ADDENDUM NO. 11

PROJECT TITLE - PA State Police Greensburg - DNA Laboratory Facility New Building

ADDENDUM 11

MEP REVISION #1 - 11/15/2022

DRAWN BY E HOOVER	DATE 05/24/2022	DRAWING NO. E114P (VOLUME 1 OF 1)
CHECKED BY S MULHOLLEN	SCALE 1/8" = 1'-0"

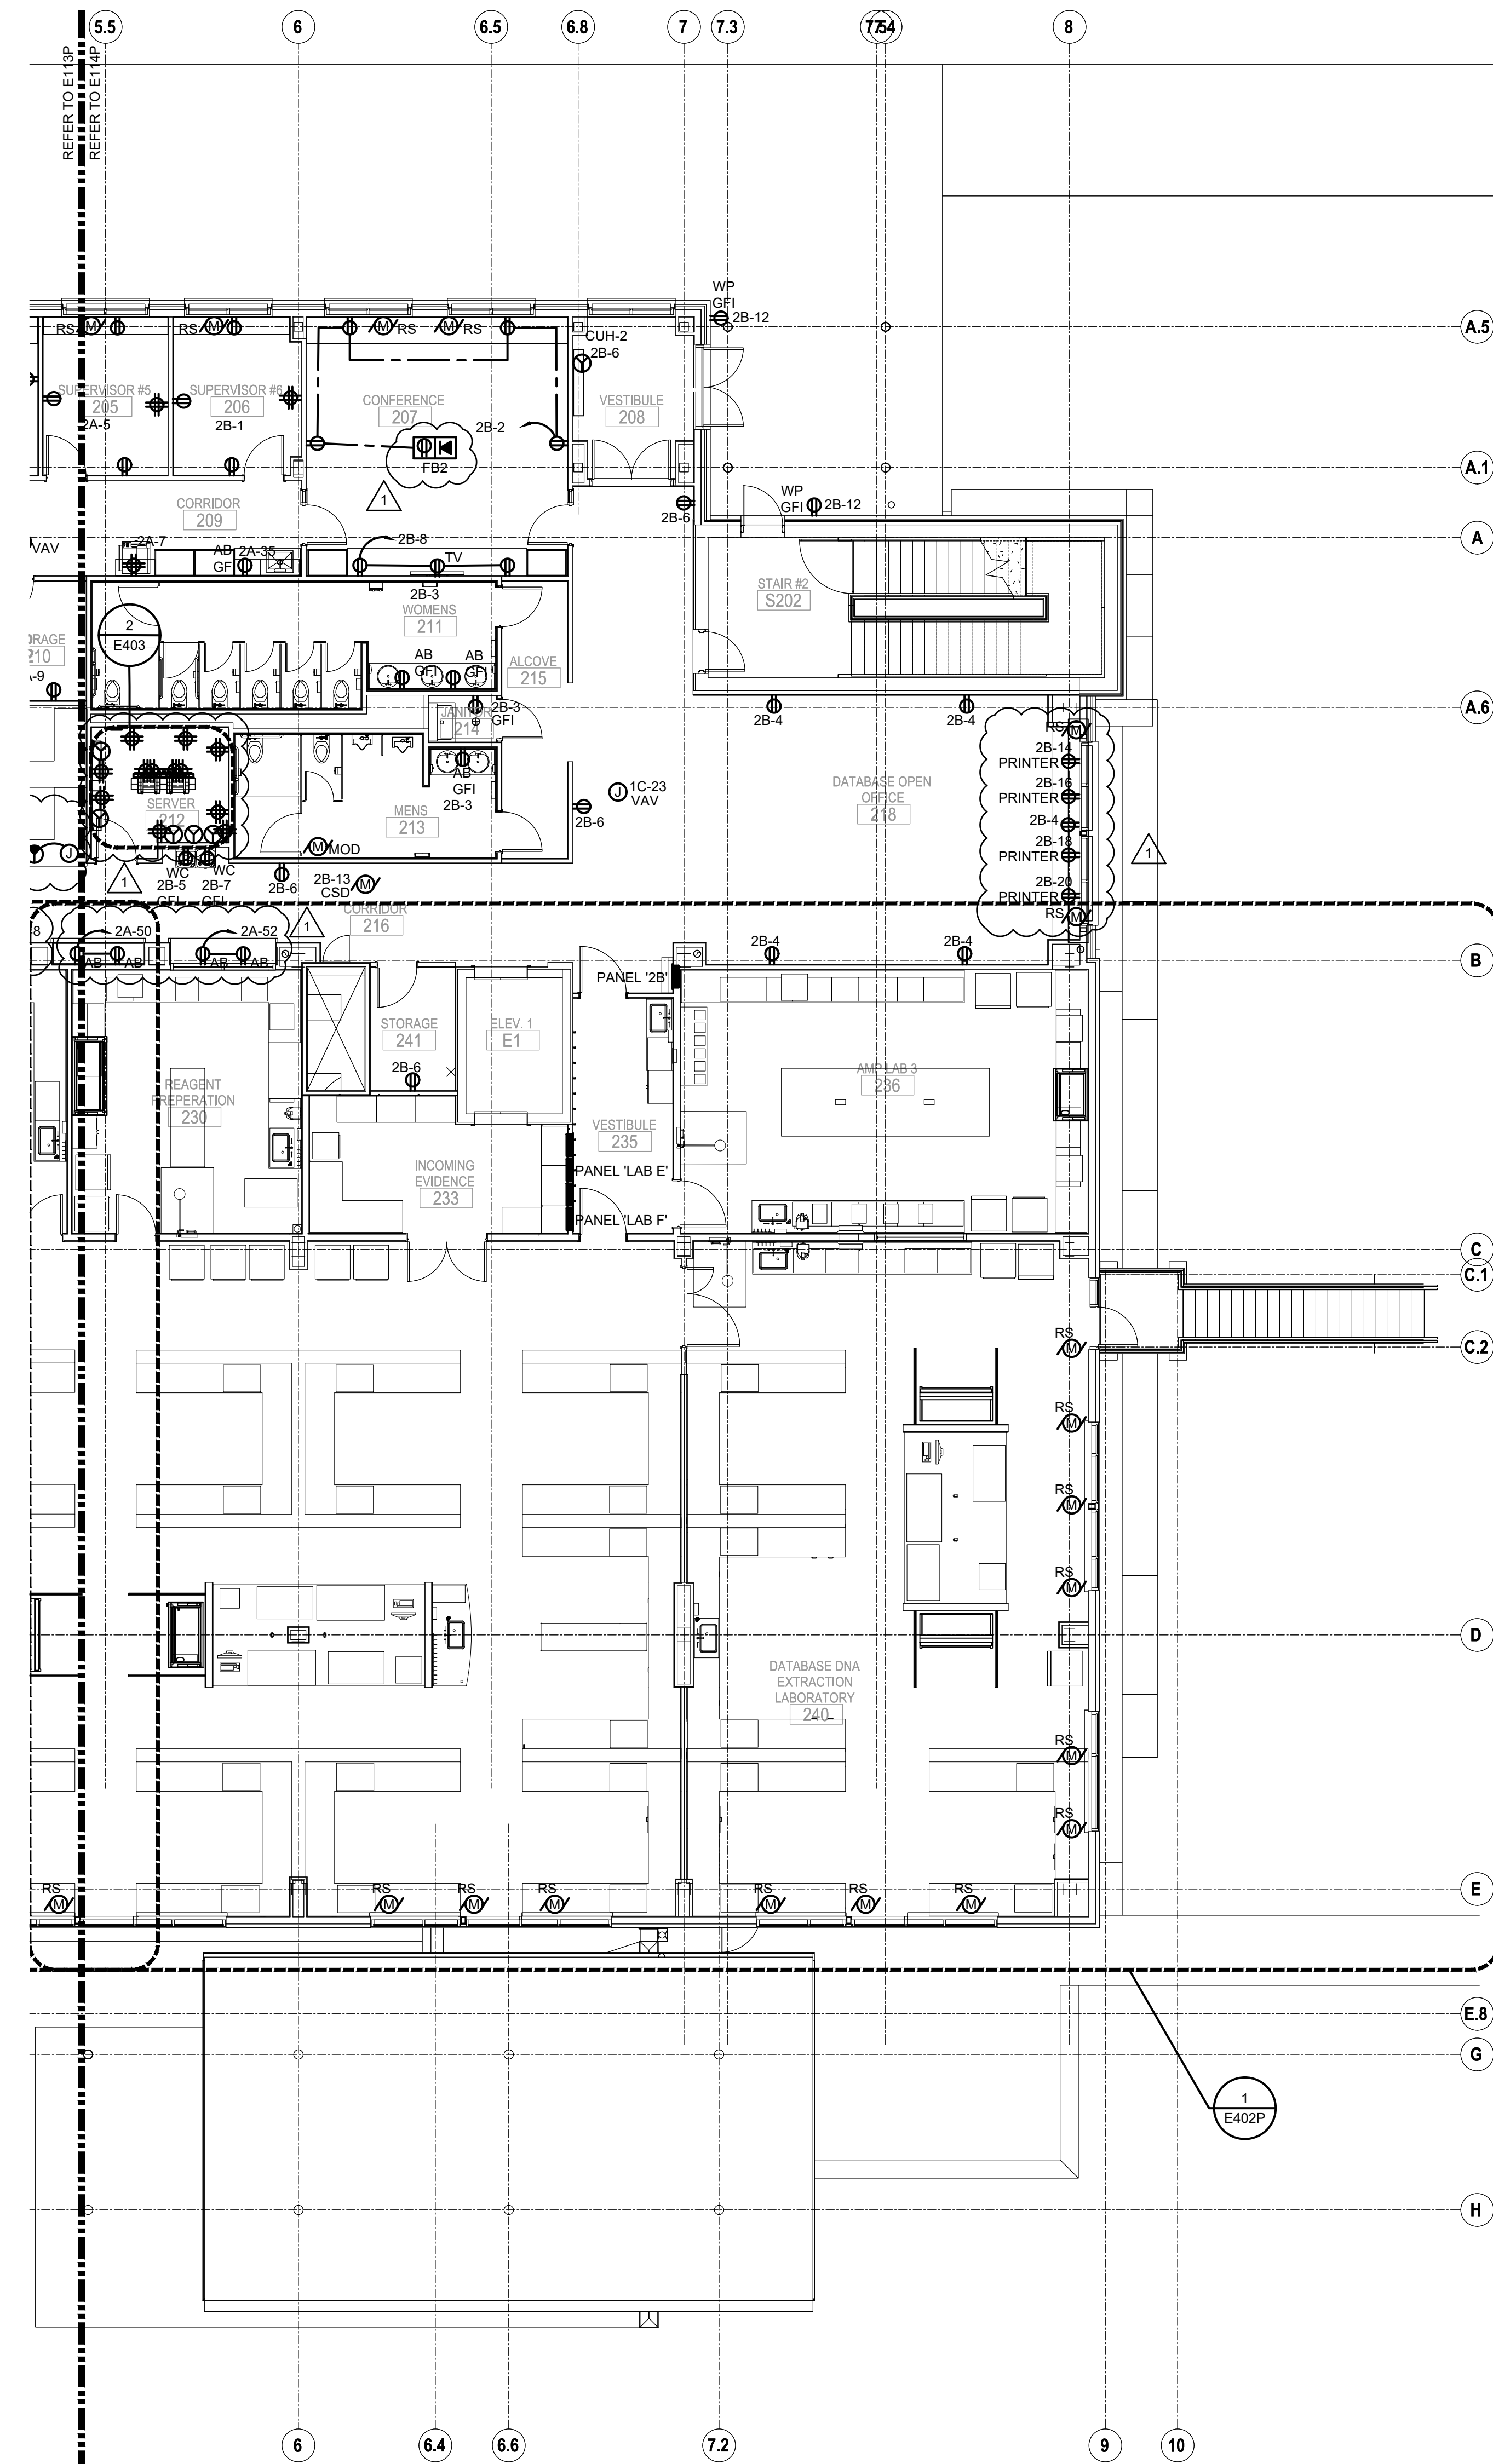
E114P - Added identification tag for Floor box in room 207.

E114P - Added power for (4) printers in room 218, assigned to panel "2B" circuits 14, 16,18, 20.

E114P - Revised Telecom Room 212 layout per client agency comments.

DRAWN BY E HOOVER	DATE 05/24/2022	DRAWING NO. E114S (VOLUME 1 OF 1)
CHECKED BY S MULHOLLEN	SCALE 1/8" = 1'-0"

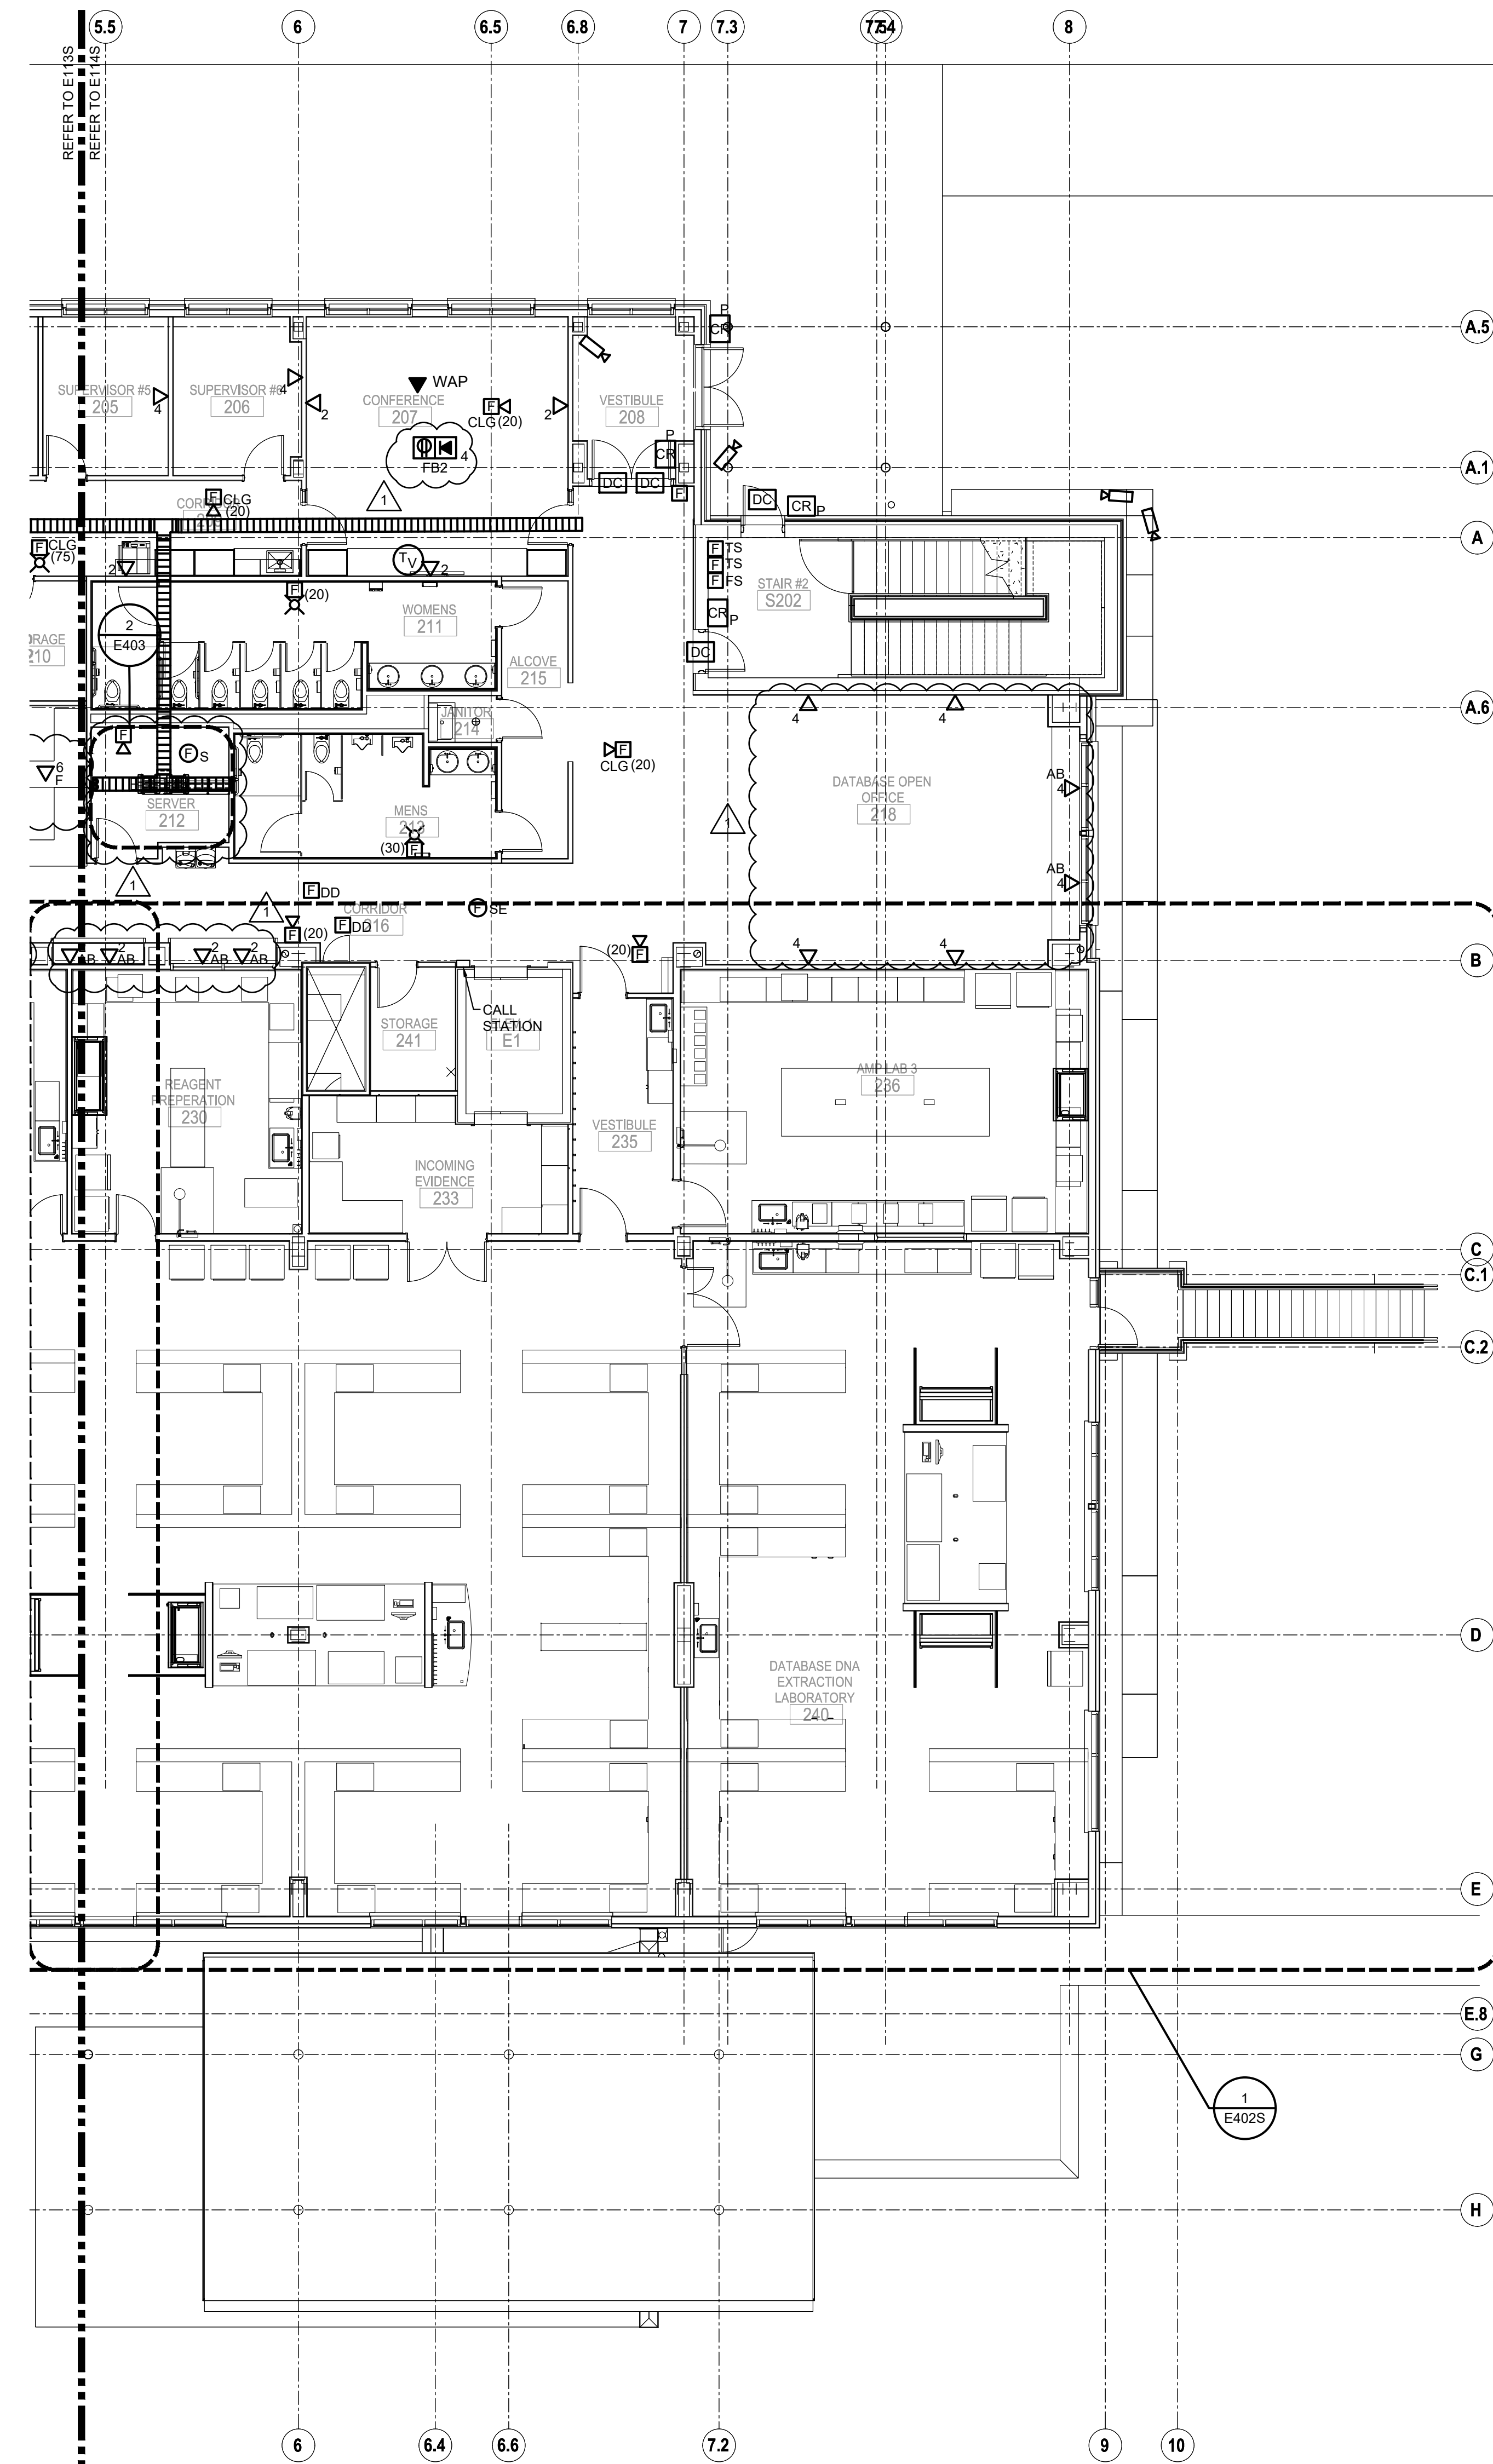
E114S - Revised Telecom Room 212 layout per client agency comments.

E114S - Added identification tag for Floor box in room 207.

E114S - Added (24) data outlets in room 218.

DRAWN BY E HOOVER	DATE 05/24/2022	DRAWING NO. E401S (VOLUME 1 OF 1)
CHECKED BY S MULHOLLEN	SCALE 1/4" = 1'-0"

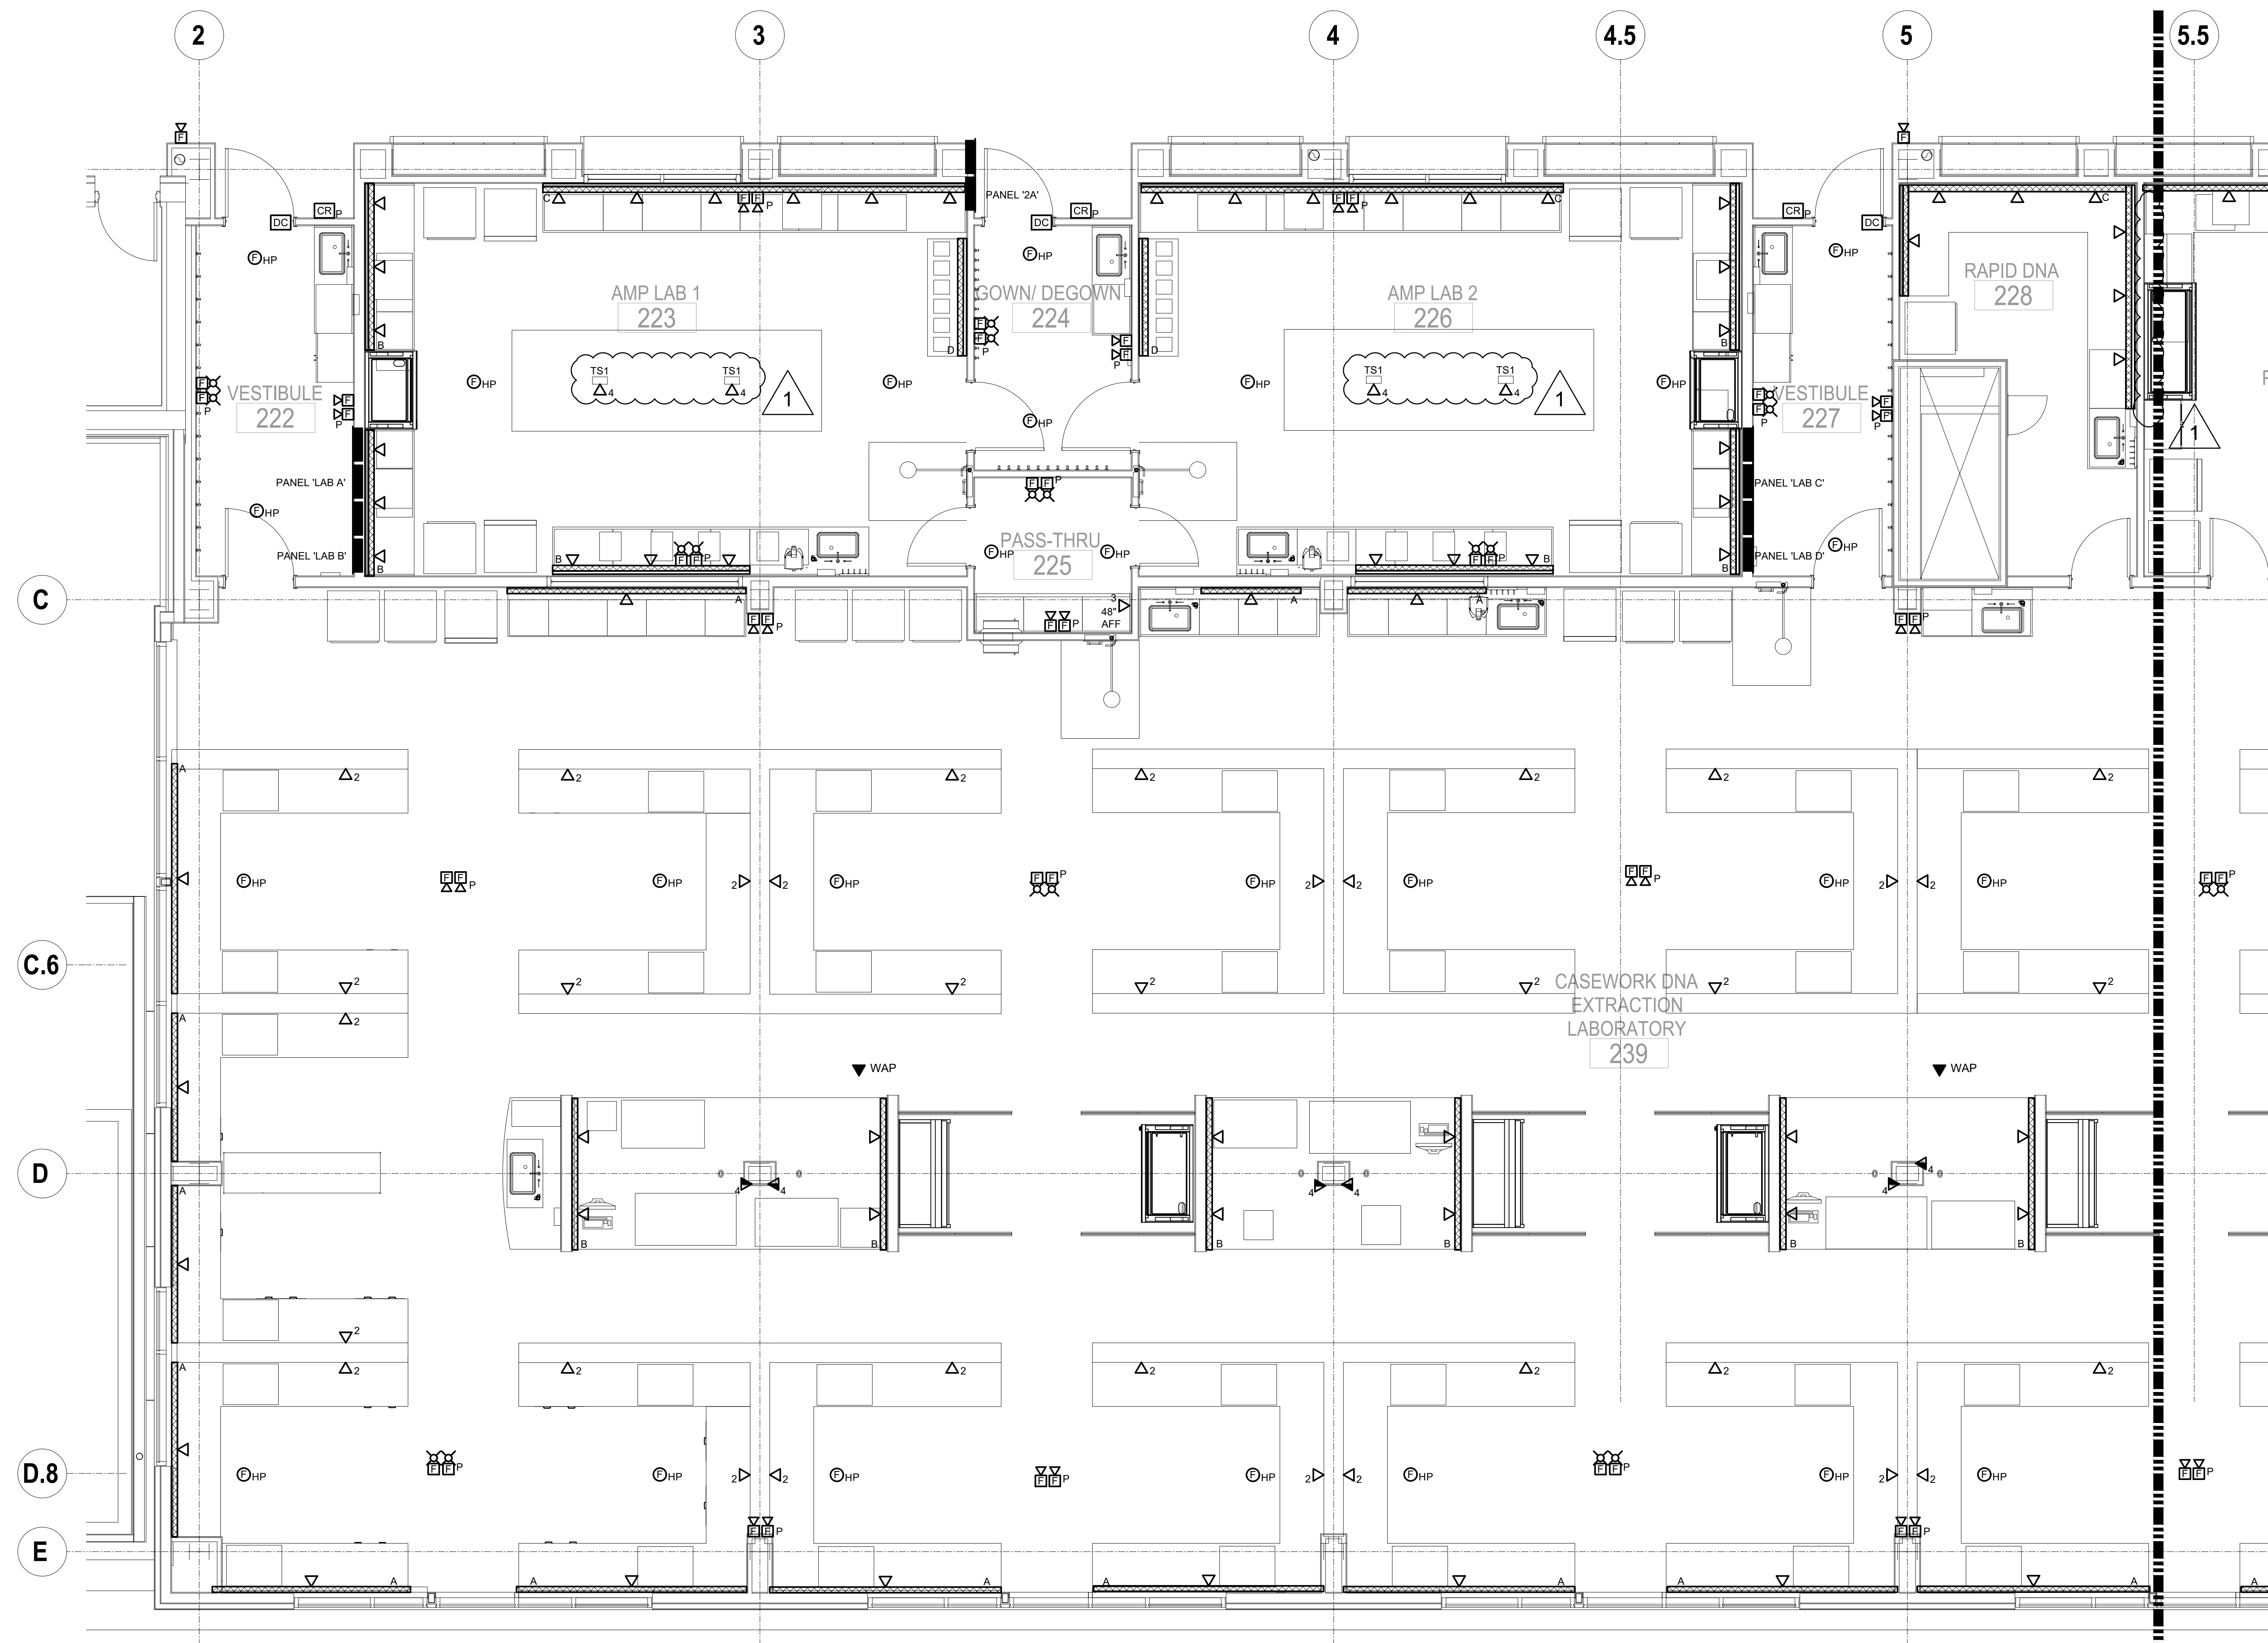
E401S/E402S - Transferred data outlets in corridor 216 to E113S & E114S for consistency with "P" plans.

E401S - Added identification tag for Tombstone pedestal boxes.
